CONTRACT CHANGE ORDER NO. ____
SHEET ____ OF ____

MARK	DATE	DESCRIPTIONS	BY	CH'D	CCO#
3	04/30/12	OBG & CROSSBEAM SEALING	DT	HT	244
2	04/02/07	CROSSBEAM KINK	GB	DT	38
1	06/23/06	STIFFENER SIZE INCREASE	GB	NV	21

SAN FRANCISCO OAKLAND BAY BRIDGE
EAST SPAN SEISMIC SAFETY PROJECT
SELF-ANCHORED SUSPENSION BRIDGE
(SUPERSTRUCTURE & TOWER)

TYPICAL CROSSBEAM DETAILS NO. 5

DETAIL H
1:2.5

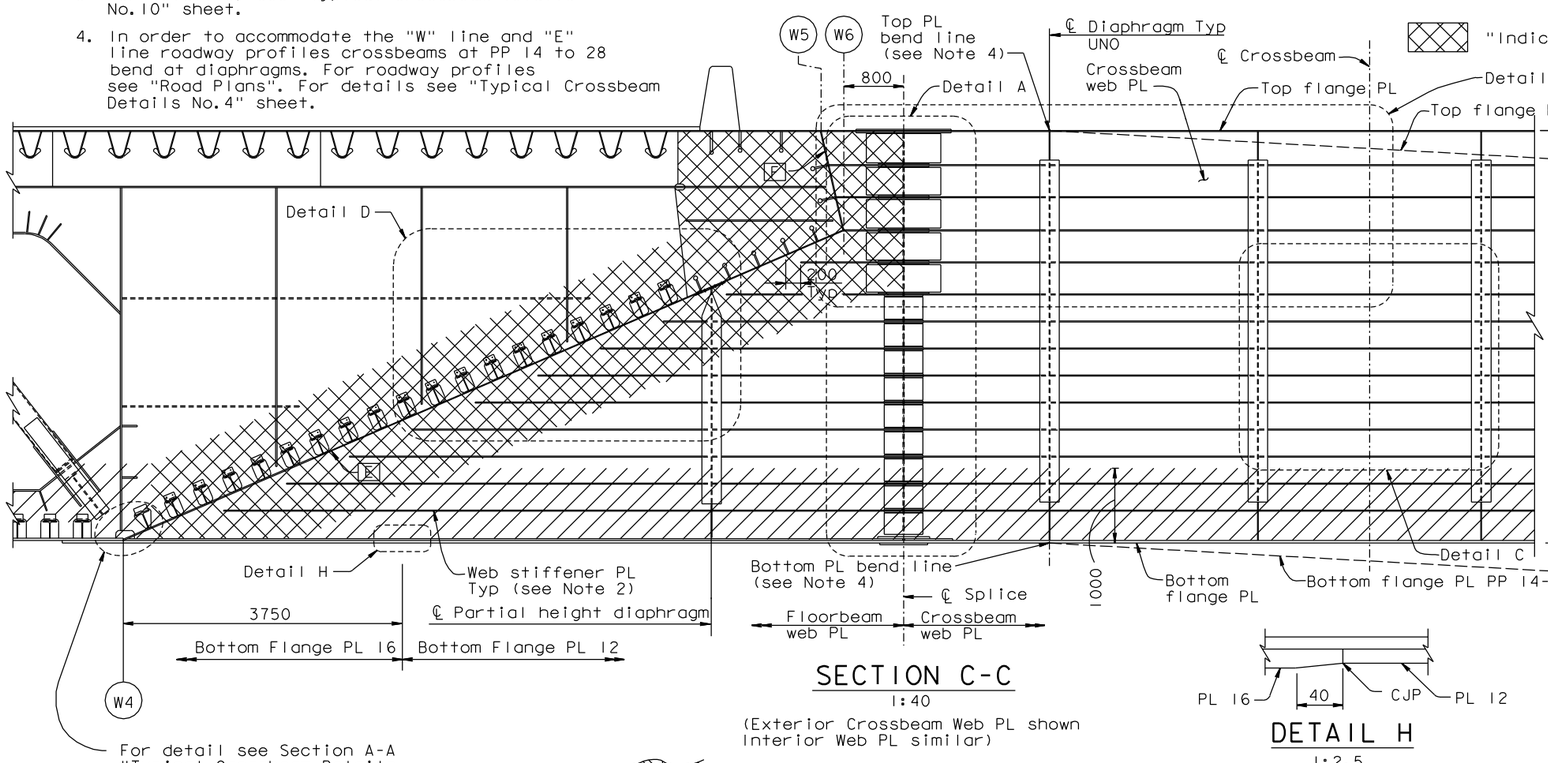
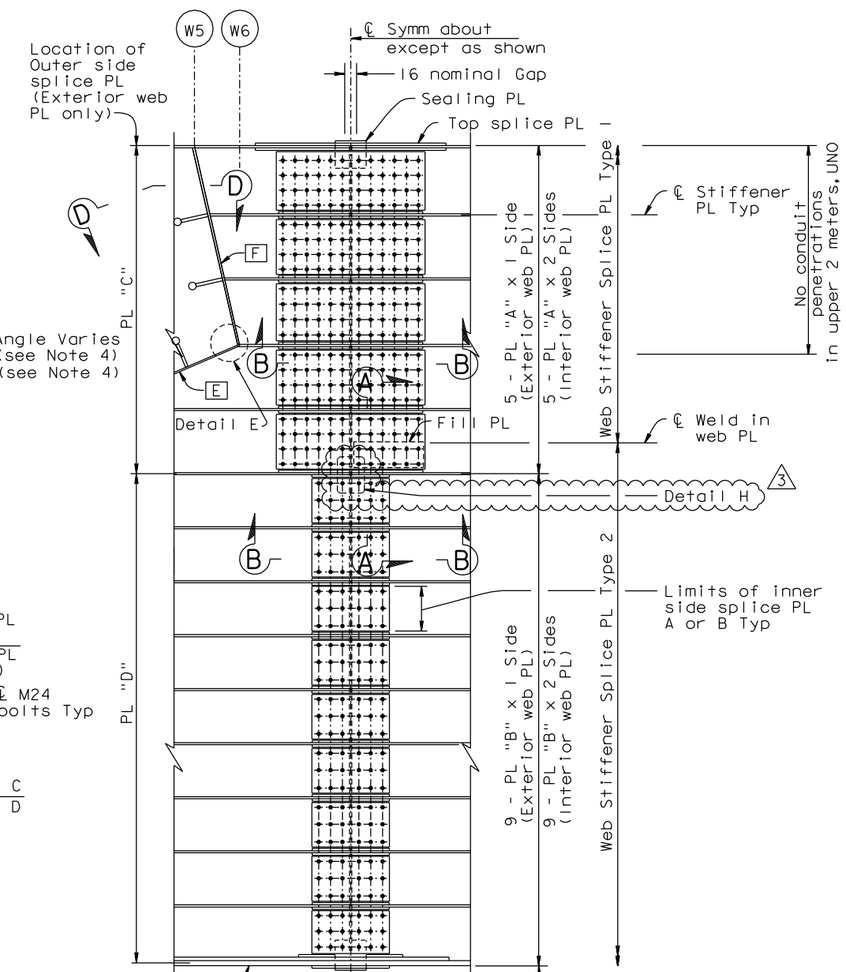
NOTES:
1. For Details C, D and E, and Section D-D, see "Typical Crossbeam Details No. 6" sheet.
2. For stiffener termination detail, see "Typical Crossbeam Details No. 6" sheet.
3. For Detail J, see "Typical Crossbeam Details No. 10" sheet.
4. In order to accommodate the "W" line and "E" line roadway profiles crossbeams at PP 14 to 28 bend at diaphragms. For roadway profiles see "Road Plans". For details see "Typical Crossbeam Details No. 4" sheet.
5. Detail H shall apply at exterior plates only. See "Typical Crossbeam Details No. 6A" sheet. (3)

DETAIL H (Exterior Web Splice Shown) (See Note 1)
1:2

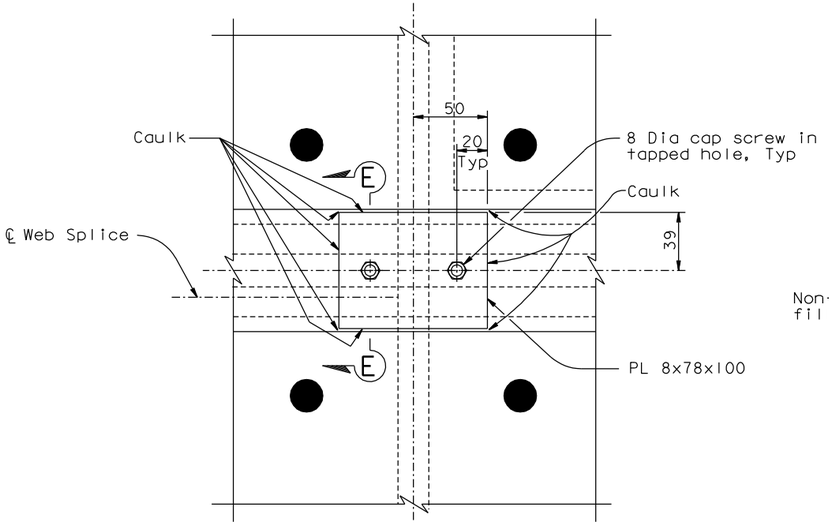
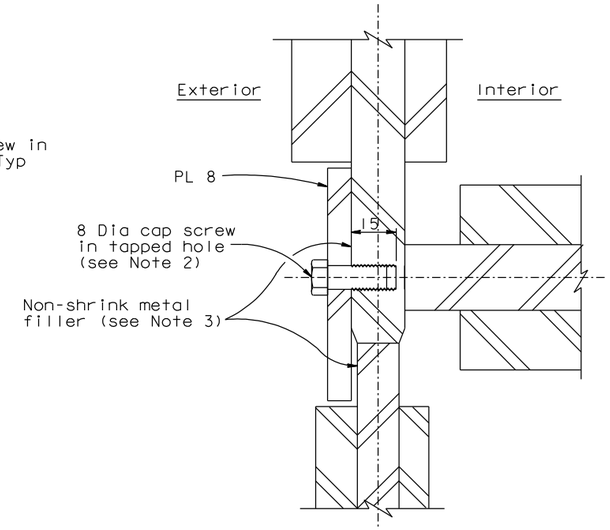
1. Detail H shall apply at exterior plates only.
2. Cap screws shall have a minimum embedment length of 12 mm in the crossbeam web plate.
3. Non-shrink metal filler shall be applied to fill gaps and provide a level faying surface for the PL 8.

MARK	DATE	DESCRIPTIONS	BY	CH'D	CCO#
0	04/30/12	OBG & CROSSBEAM SEALING	DT	HT	244

BOTTOM GIRDER FACE LAYOUT

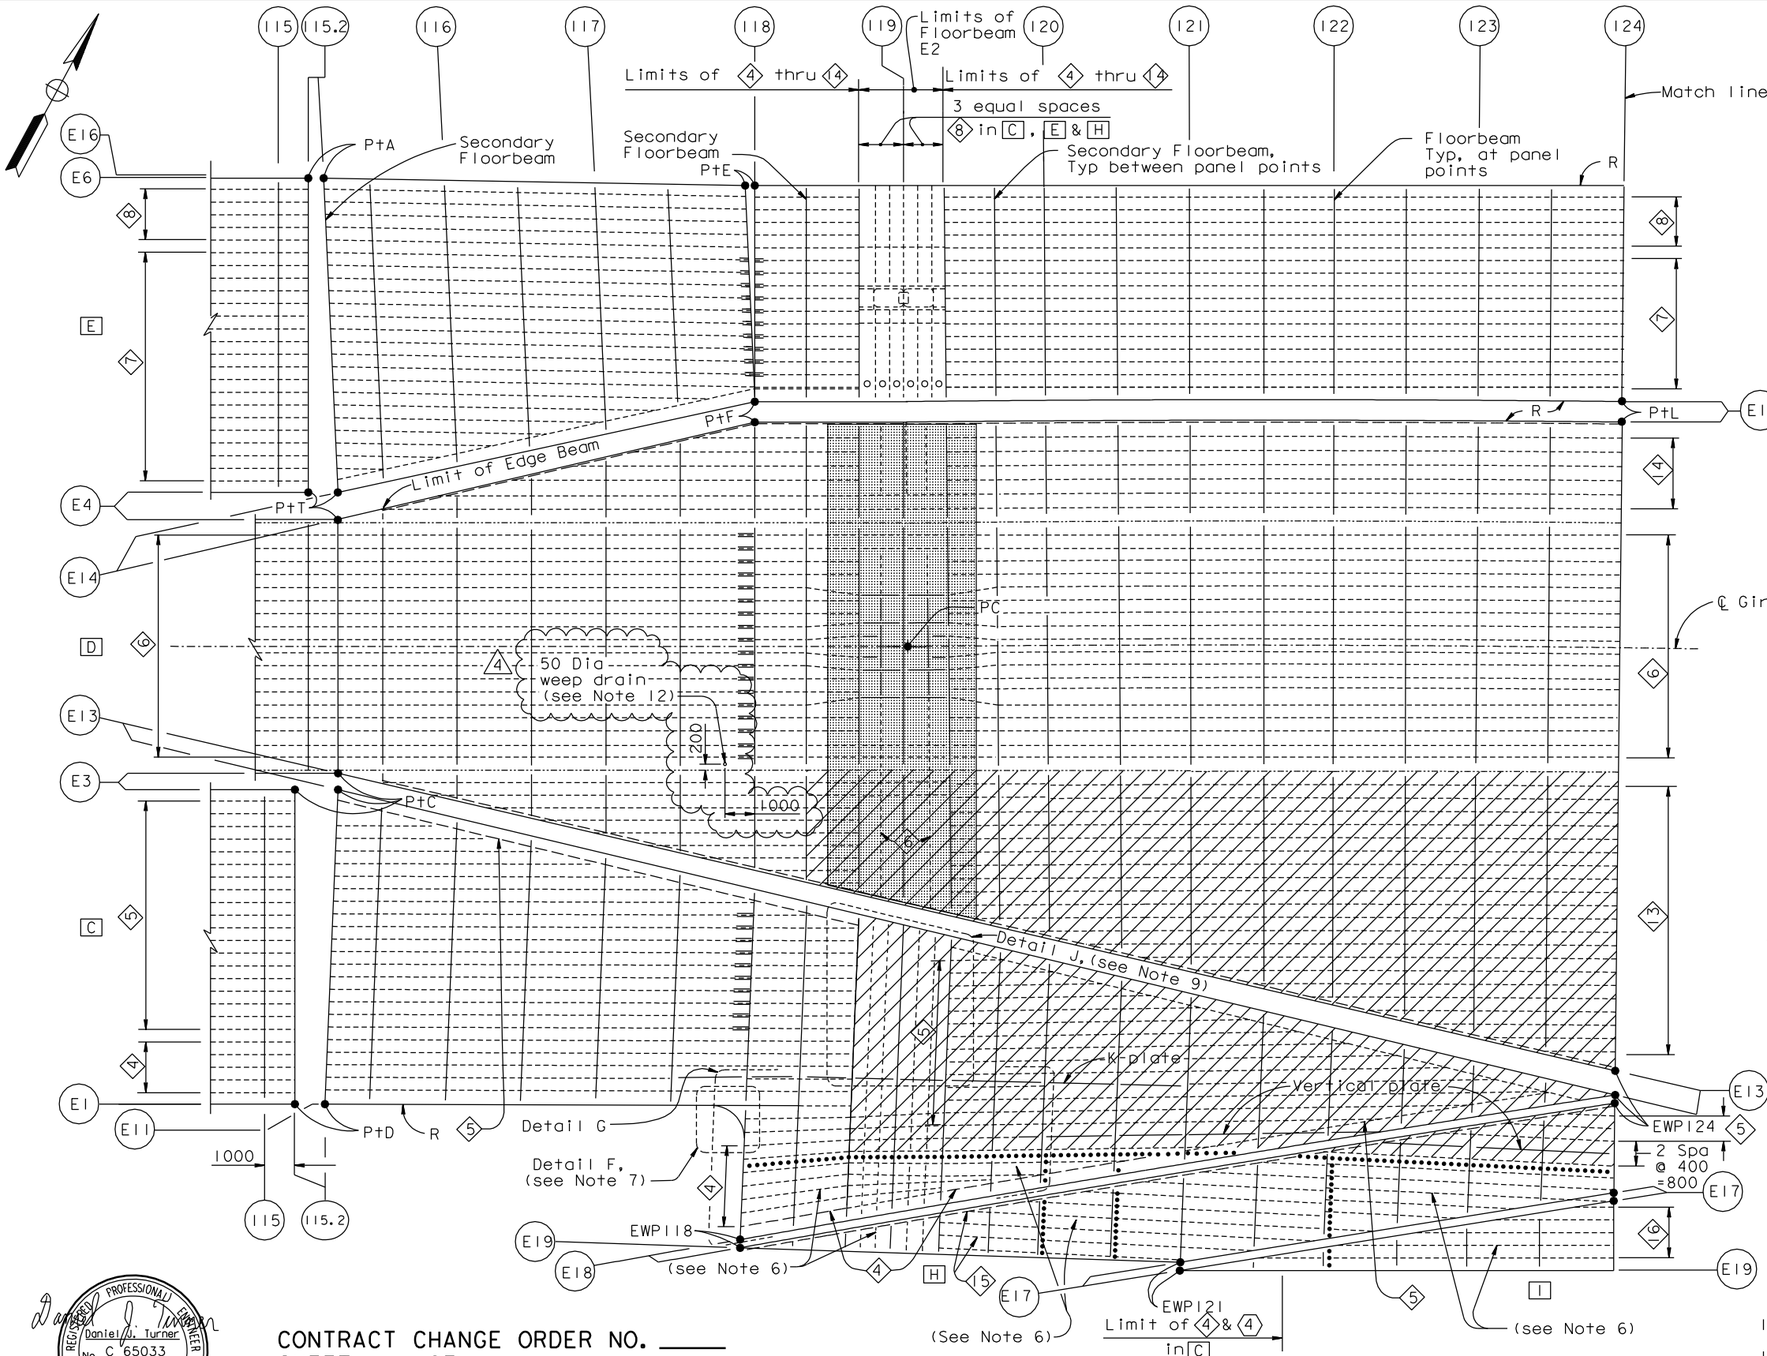
12. (4) Provide weep drain at corresponding location adjacent to W4 Line.

MARK	DATE	DESCRIPTIONS	BY	CH'D	CCO#
4	04/30/12	OBG & CROSSBEAM SEALING	DT	HT	244
3	03/21/12	EAST END OBG	DT	GB	87
2	03/02/12	OBG RETROFIT AT PP119	GB	MN	238
1	05/20/11	STIFFENER TRANSITIONS AT PP14 & PP118	DT	GB	204

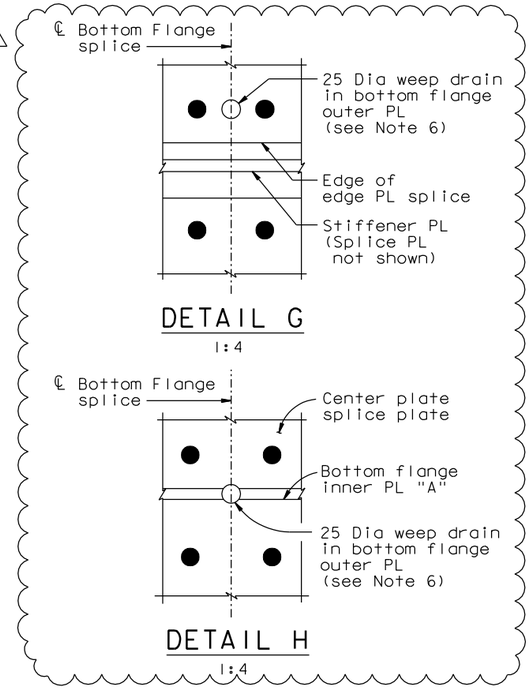
1. For details not shown, see "Typical Crossbeam Details No.8" sheet.
2. For details not shown, see "Typical Crossbeam Details" sheets.
3. At the Contractor's option, the stiffener splice PL length may be reduced to 1740, subject to review and approval of the Engineer.
4. For crossbeam segments which vary in depth within the specified tolerances, the Contractor shall use fill plates in the bottom splice to correct for the variation. Fill plates shown on the plans shall be adjusted as required to bring splice plates into contact.
5. At the Contractor's option, it is acceptable to space the M30 bolts at 90 mm, subject to review and approval of the Engineer.
6. Inside surfaces of weep drain shall be finish painted. (2)

MARK	DATE	DESCRIPTIONS	BY	CH'D	CCO#
2	04/30/12	OBG & CROSSBEAM SEALING	DT	HT	244
1	09/01/11	EAST END OBG	DT	GB	87

SECTION C-C
1:1

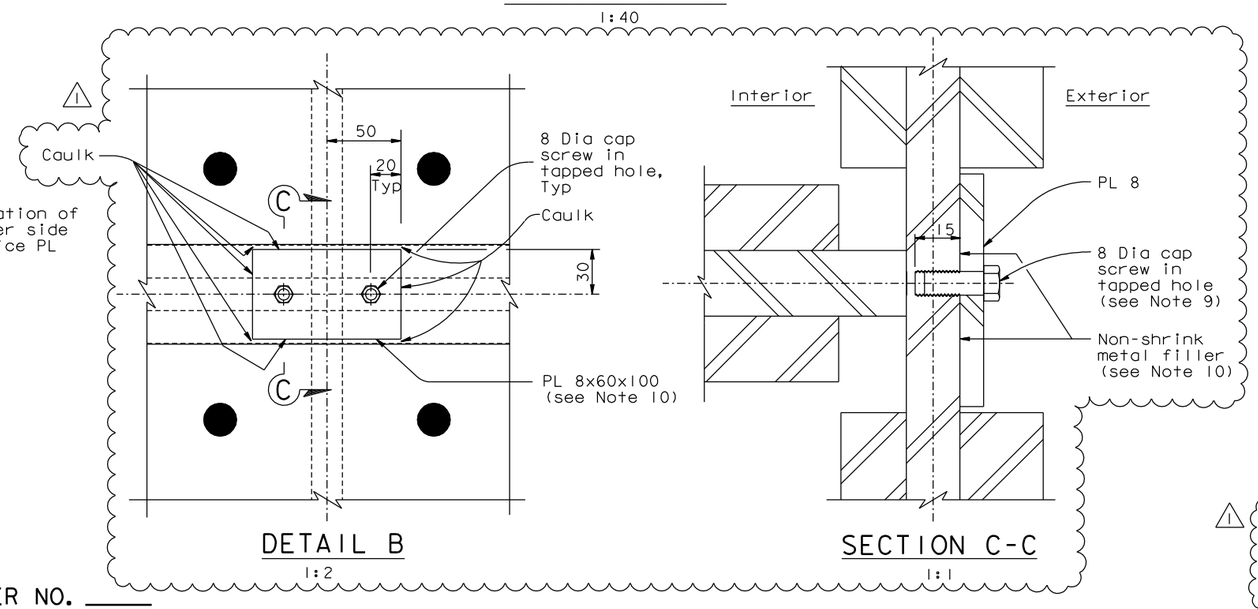
1. For details at girder access opening, see "Typical Girder Details No.15" sheet.
2. For details of crossbeam access opening not shown, see "Typical Crossbeam Details No.6" sheet.
3. For details not shown, see "Typical Crossbeam Details" sheets.
4. For layout of E2 floorbeam web, see "Girder At Pier E2 No.4" sheet.
5. For girder access locations, see "Girder Access Details No.3" sheet.
6. For details not shown, see "Typical Crossbeam Details No.5" sheet.
7. Transitions not required for crossbeam web stiffeners terminating at Face F.
8. For Section D-D, see "Crossbeam At Pier E2 No.5" sheet.
9. Cap screws shall have a minimum embedment length of 12 mm in the crossbeam web plate. (1)
10. Non-shrink metal filler shall be applied to fill gaps and provide a level faying surface for the PL 8.

MARK	DATE	DESCRIPTIONS	BY	CH'D	CCO#
1	04/30/12	OBG & CROSSBEAM SEALING	DT	HT	244
0	04/18/12	EAST END OBG	GB	MN	87

DETAIL H (See Note 2)
1:2

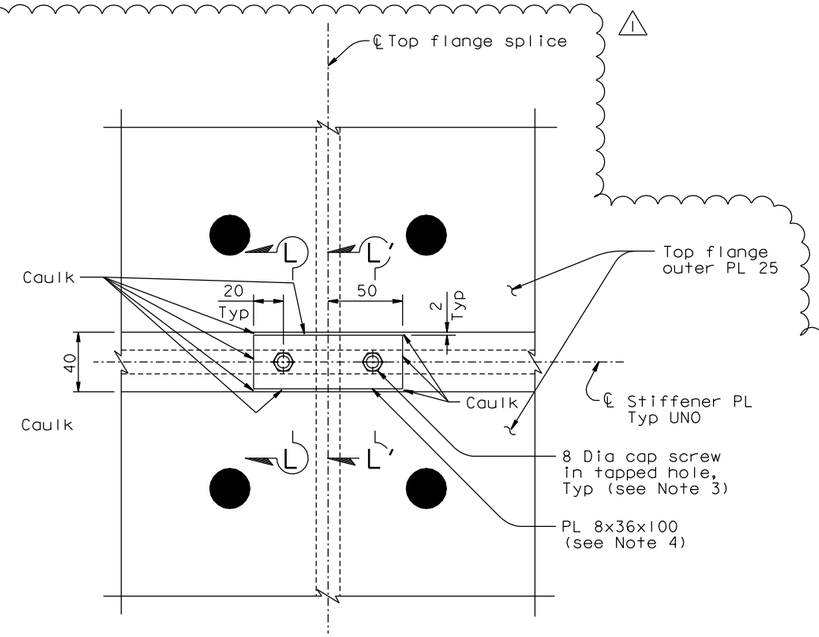
1. At the Contractor's option, optional Detail C may be used to provide additional clearance in the case of Crossbeam to OBG misalignment, subject to review and approval of the Engineer.
2. Detail H is typical for all gaps between top flange exterior splice plates.
3. Cap screws shall have a minimum embedment length of 12 mm in the deck plate and crossbeam top flange plate.
4. Non-shrink metal filler shall be applied to fill gaps and provide a level faying surface for the PL 8.
5. Inside surfaces of weep drains shall be finish painted.
6. 50 Dia weep drains are required at Crossbeam at East Anchorage to "W" Line girder splice only.

MARK	DATE	DESCRIPTIONS	BY	CH'D	CCO#
1	04/30/12	OBG & CROSSBEAM SEALING	DT	HT	244
0	09/01/11	EAST END OBG	DT	GB	87
